Mr. Alex Forbes
Manager Planning & Heritage
Planning & Heritage Department
70 Kent Street
Charlottetown, PE
C1A 1M9
Planning@charlottetown.ca

July 2, 2021

I, Andrea Battison, as an aggrieved person respectfully request that the City of Charlottetown reconsider the approval of the site specific exemption amendment for 199 Grafton Street (207-BYL-21) which passed second reading of Council on June 14, 2021. This request is made under provisions 3.15.3.a and 3.15.3.c of Section 3.15 Reconsideration, of the Charlottetown Zoning and Development Bylaw (hereafter referred to as 'the *Bylaw*').

Figure 1. Excerpt from page 69, *The 500 Lots Standards and Guidelines*. Note the use of progressively diminishing height away from the Downtown Core (DC) area. The dashed box shows the area of proposed development. Legend indicates a maximum of five (5) storeys or 18 m (60.7 ft) for that area.

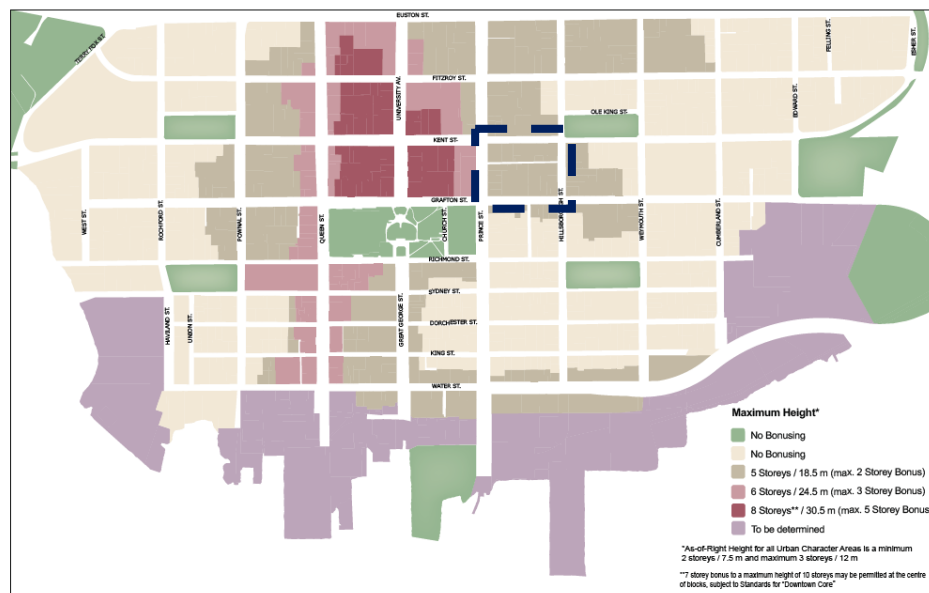
The 500 Lots Standards clearly indicate a maximum height of 60.7 ft, inclusive of bonus height, in the block containing the 199 Grafton Street proposal. This allows for the design principle of progressive diminishing of height from the Downtown Core (DC) zone into the Downtown Mixed Use Neighbourhood (DMUN) Zone.

It is argued that as the proposed building, at an average height of 70.4 ft, is higher than allowed for the zone, and higher than any other building in the immediate area, it would disrupt the progressive decrease in height from the DC to DMUN zone and so approval of the proposal would reflect poor planning principles.

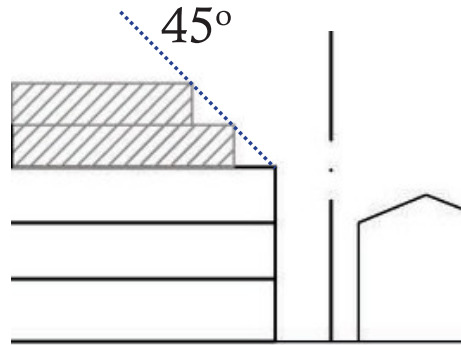
However, the property at 142-146 Prince Street represents the flank yard beside a building applying for bonus height. A definition of ‘flank’ does not appear in the Appendices of the Bylaw and so the general definition of a flank as a ‘side’ can be applied.

Given that the building at 142-146 Prince Street is residential and that the entire block is zone DMUN, and that Sections 30.3.2.a and 30.3.2.b have been applied to calculate the frontage and step back variance requests for the proposed building, section 30.3.2.c.ii and 30.3.2.c.iii should also apply:

Given that the height of the fourth and fifth storeys in the proposed building are each 10' 11", and the requirement for a 45° (degree) angular plane per point (iv) above, the side yard step backs for the fifth and sixth storeys should each be 10' 11".

It is argued that the side (flank) yard abutting 142 -146 Prince Street requires step backs of 10' 11" at the fourth and fifth storeys. These variances were not included in the request for a site specific amendment and therefore the request is incomplete.

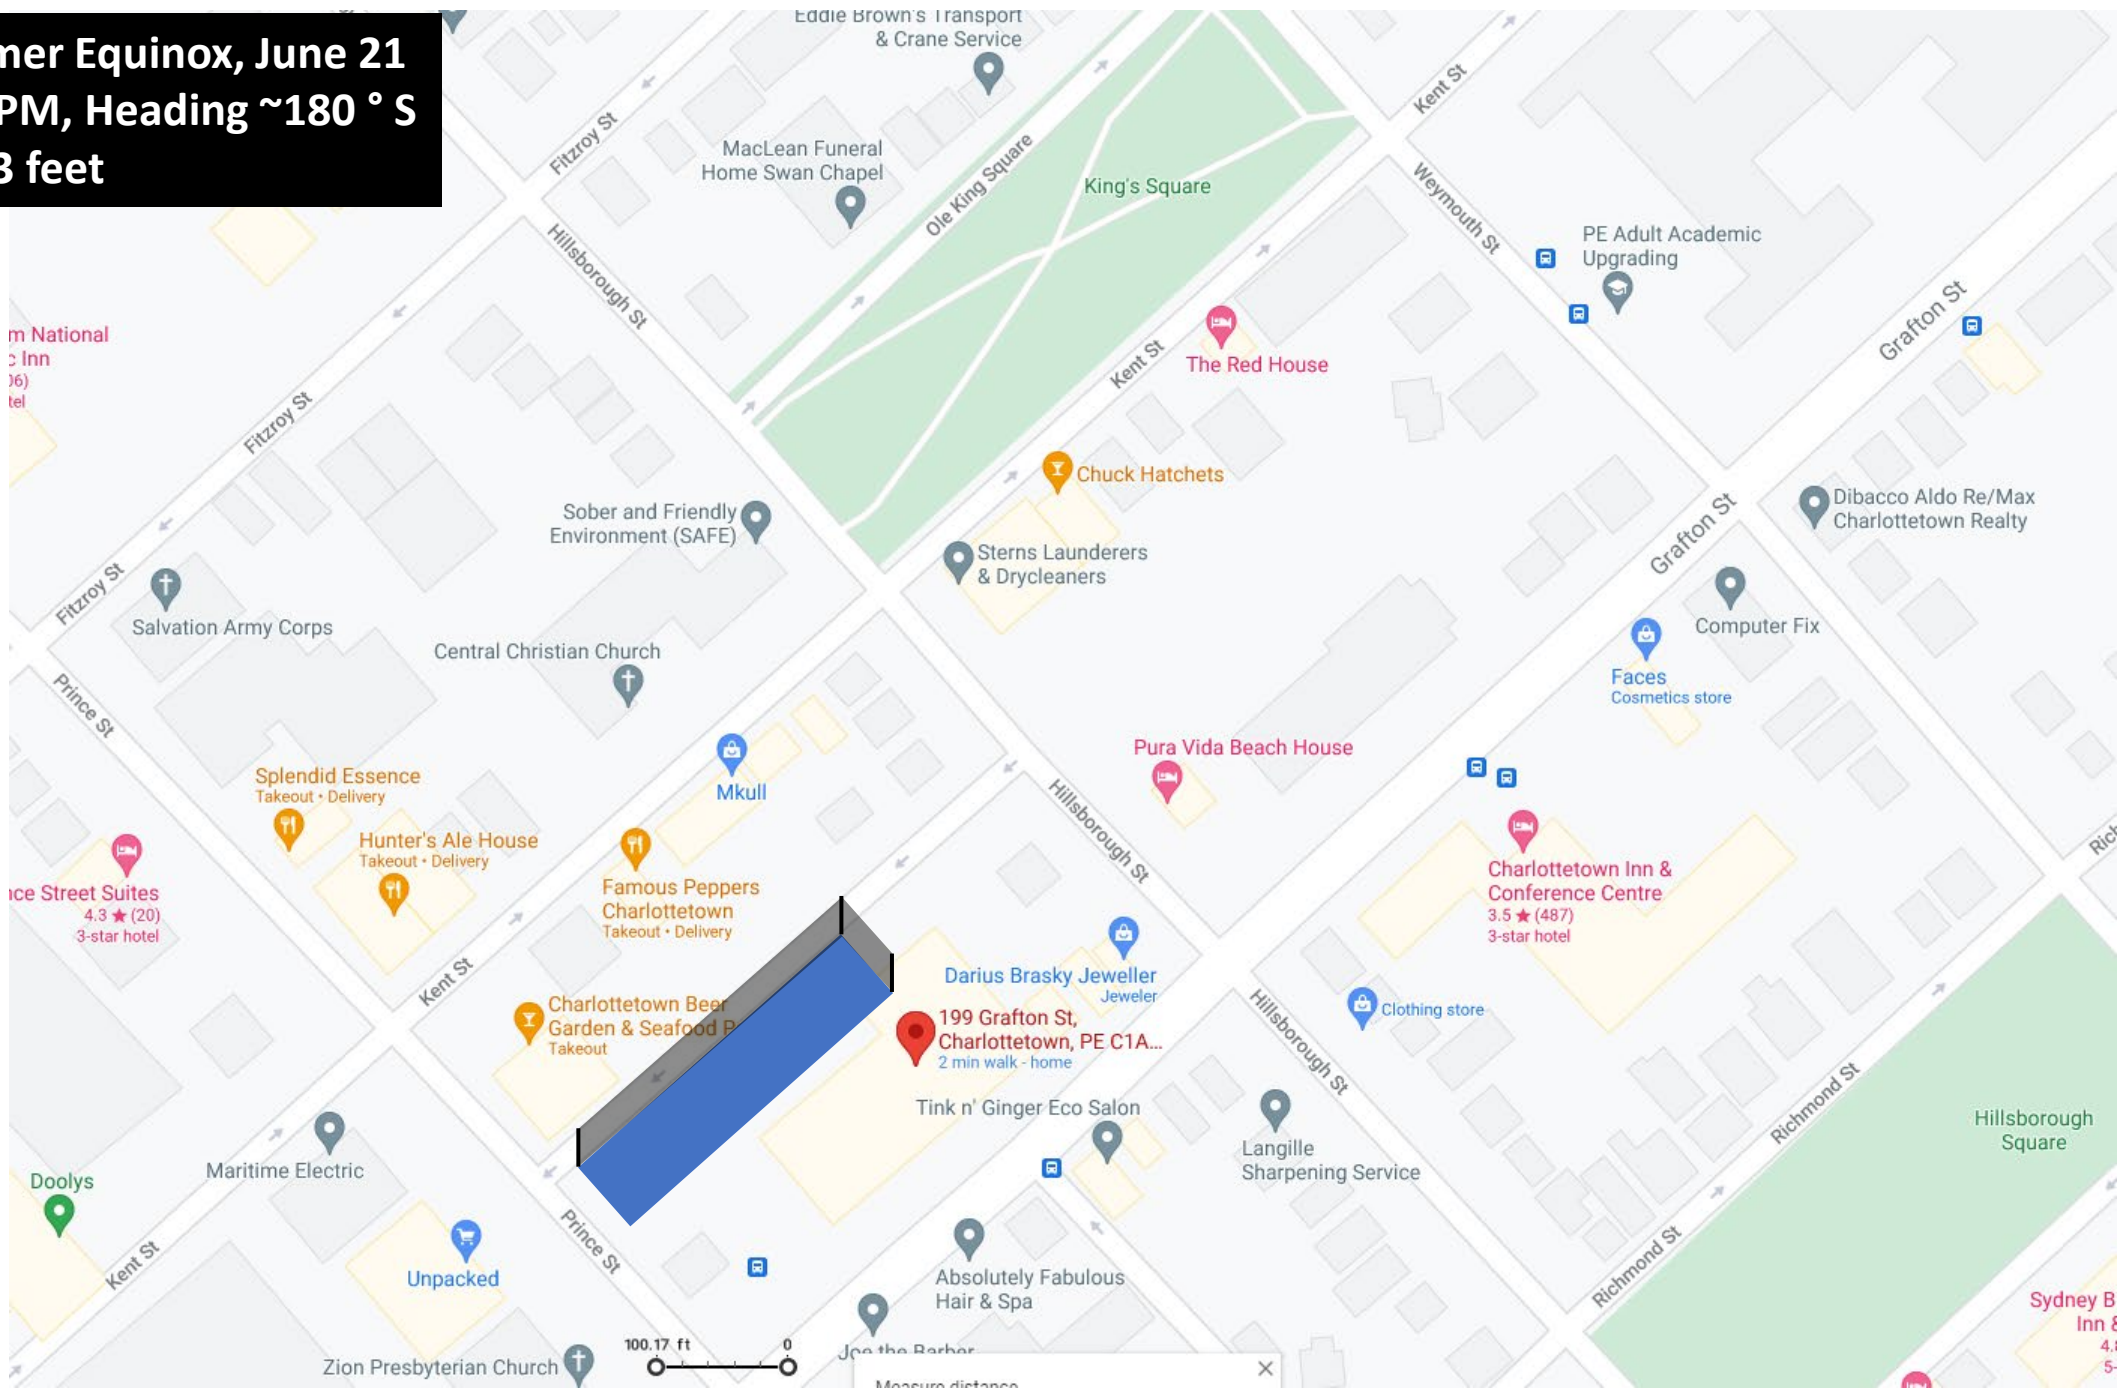
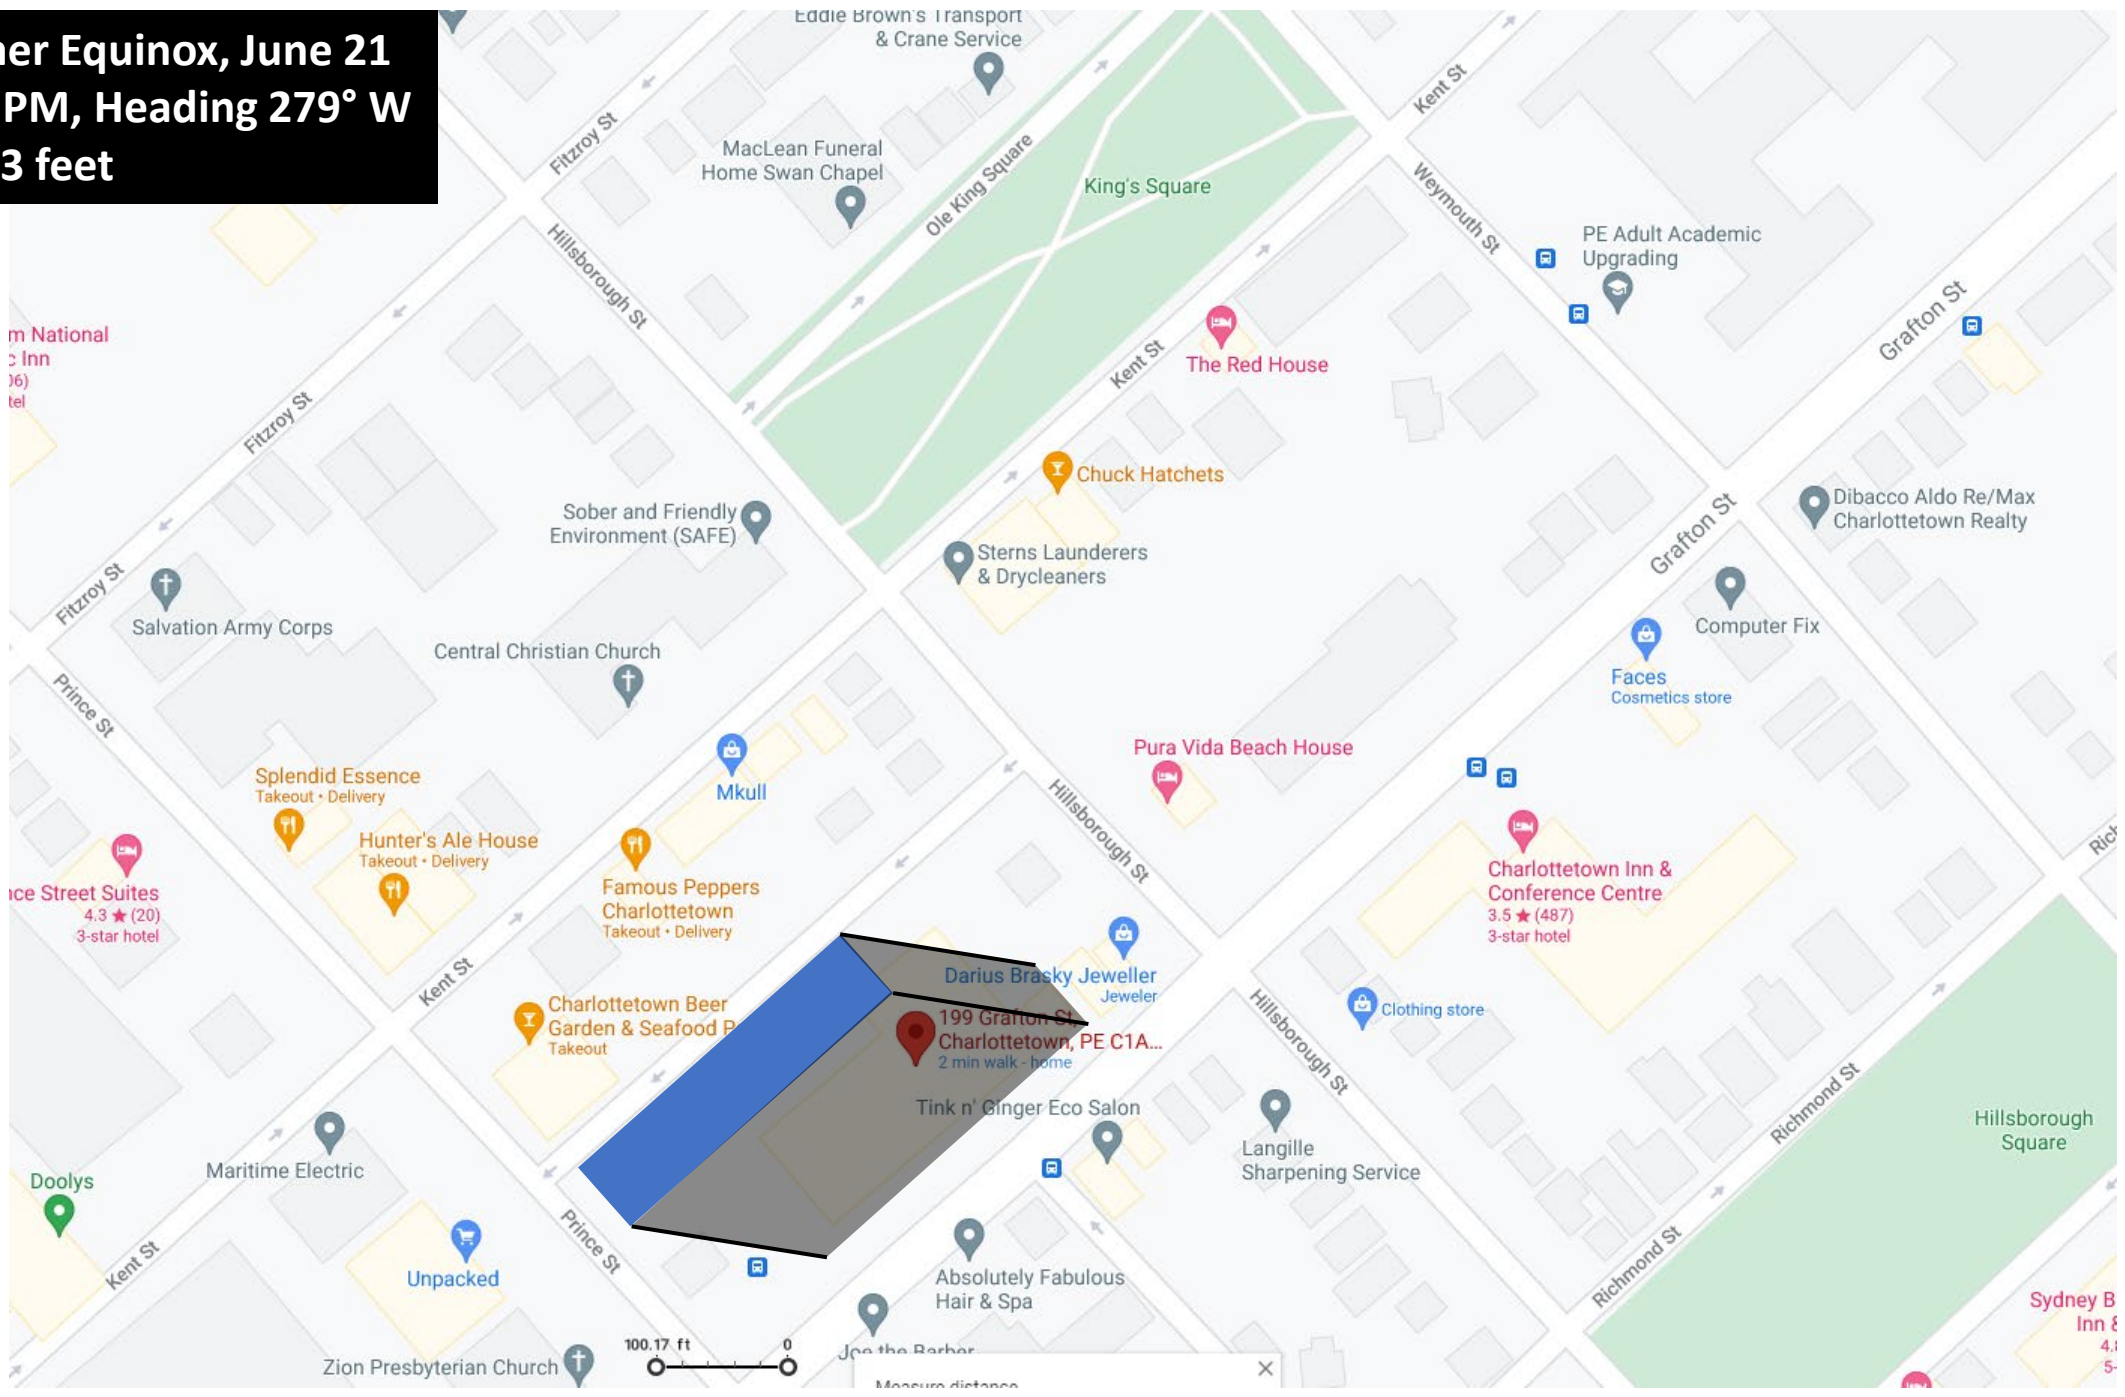
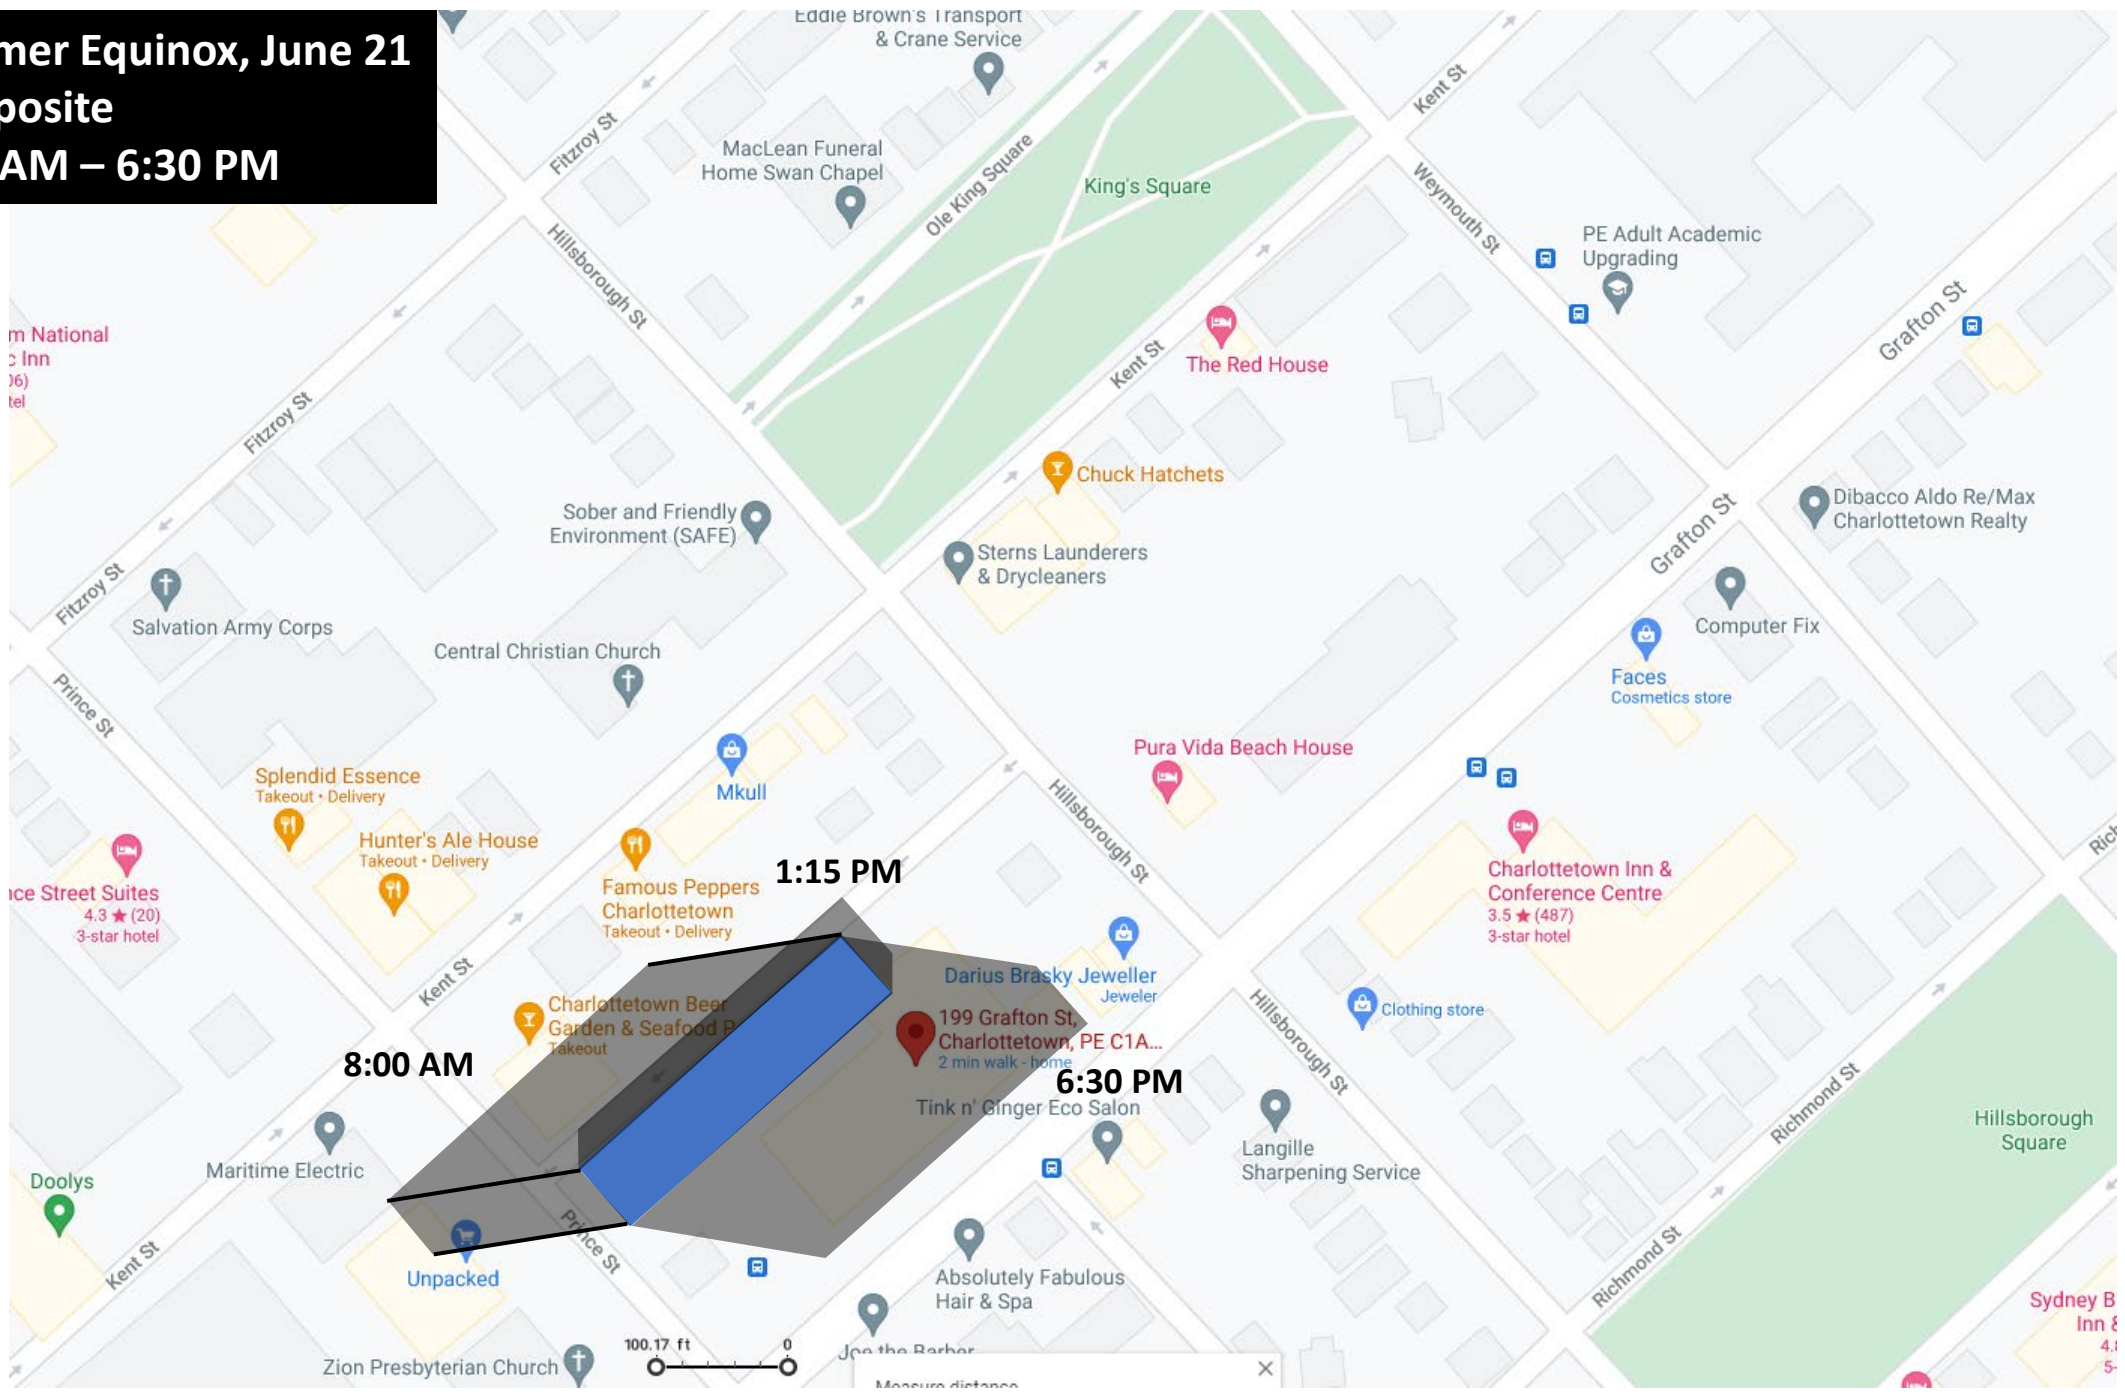
The shadow diagrams in Appendix A, are not as accurate nor as complete as professionally prepared ones for a shadow impact study which would comprise cumulative shadows and show a change in shadows. They do however, at a minimum, indicate that shadows could be a relevant feature of this proposal and that a shadow impact study would be valuable in assessing to what degree the height and length of the building will affect neighbouring residents.

Given the potential for negative impact on health due to decreased access to sunlight that the current residents on Kent Street are accustomed to and limitation of the use of solar panels, it is argued that a shadow impact study is required.
